DEADLINE 7 SUBMISSION**STONE HILL PARK LTD'S COMMENTS ON THE APPLICANT'S RESPONSE TO EXA'S SECOND WRITTEN QUESTIONS****PINS APPLICATION REFERENCE: TR020002**

Please find below SHP's comments on the Applicant's Answers to Second Written Questions [REP6-012].

DEDICATED FREIGHTERS CARRY – AND WILL CONTINUE TO CARRY – MORE THAN HALF OF AIR CARGO TRAFFIC

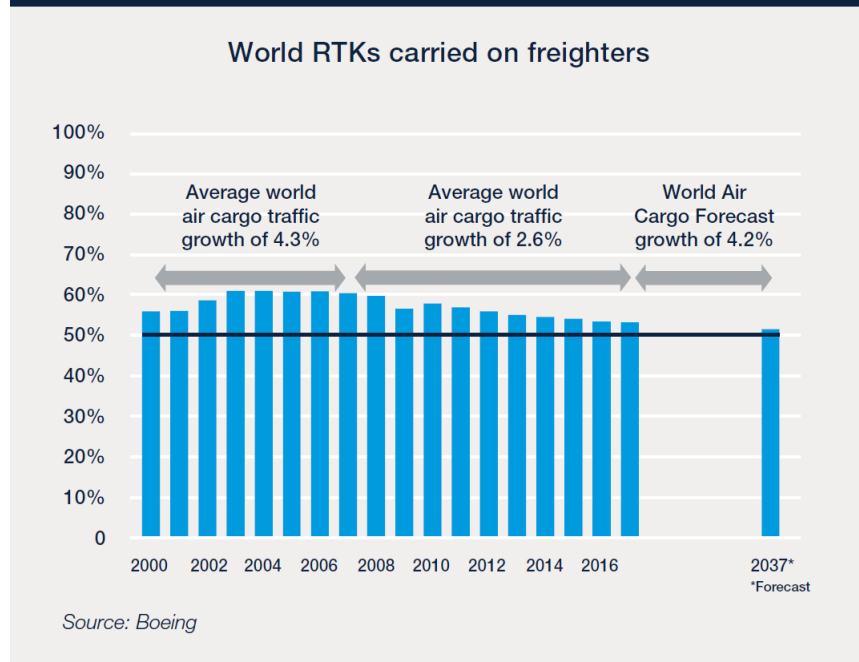
ND.2.14	In this response, it is claimed that the e-commerce integrator would be serving routes mainly to the US and Far East. It is totally unclear why an e-commerce integrator would be concentrating on exporting goods to the Far East and the USA as stated in the response to ND.2.6. Surely the key feature of Rockford and the role it plays in the US supply chain is its central location between E and W coasts of the USA. The UK equivalent would be East Midlands and, for Europe, this role is fulfilled by airports such as Liege and Leipzig.
ND.2.15	The response provided regarding the accuracy of Boeing and Airbus forecasts shows that Boeing was reasonably accurate in a 20 year projection of the total aircraft fleet but overstated demand for pure freighter aircraft by 25%. What the graphic provided shows is a reasonable degree of accuracy in forecasting total aircraft and revenue passenger miles but a significant overstatement of demand for pure freighters. The Applicant is wrong to state that Boeing does not project a decline in the share of freight carried in dedicated freighters globally. The Boeing 2018 Forecasts (https://www.boeing.com/resources/boeingdotcom/commercial/market/commercial-market-outlook/assets/downloads/2018-cmo-09-11.pdf) actually show a predicted reduction in the share of FTKs on freighters:

The reduction in the share of freighter aircraft movements will exceed that of RTKs due to increased tonnage per aircraft. If cargo growth undershoots 4.2% p.a. as seems likely given short term trends, the role of freighters is likely to be less (compare the previous period with 4.3% growth to the more recent period with 2.6% growth when the role of freighters declined).

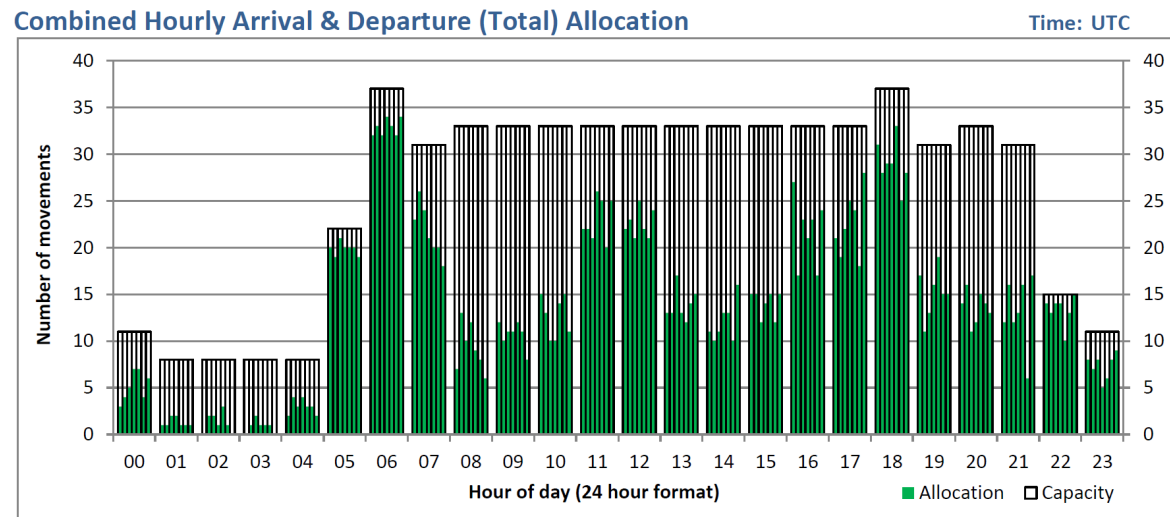
Ns.2.21	As noted in response to ND.2.35 above, the Applicant clearly does not understand the point being made: with 15% of arrivals at night this equates to 40% of based aircraft requiring a movement in the night period as part of their overall daily pattern of rotations as, by definition, the remainder of flight operations are outside of the night time period. Therefore, the effect of any restriction in operations after 23.00 (notwithstanding that Manston many avail of marginally shorter flight times on some sectors) reduces the likelihood of aircraft being based. As the majority of passengers forecast to use Manston are claimed to be on based aircraft, this is an important consideration. The reason that Luton was chosen as the example in York Aviation’s Note of Oral Evidence given at the Noise Hearing submitted at Deadline 5 [REP5-032] is because that was Mr Freudmann’s example given in oral evidence. The night movements arise by consequence of the rotation pattern of aircraft to maximise economic usage of the available flying hours not any slot restrictions in the period leading up to the night time. To the extent that there are operational constraints at Luton currently, the limiting factor is availability of stands for overnight aircraft

parking rather than slots in the period leading up to 23.00 as can be seen in Luton's pre-season scheduling report for Summer 2018 (<https://www.acl-uk.org/airport-info/>), which shows ample slots to be available.
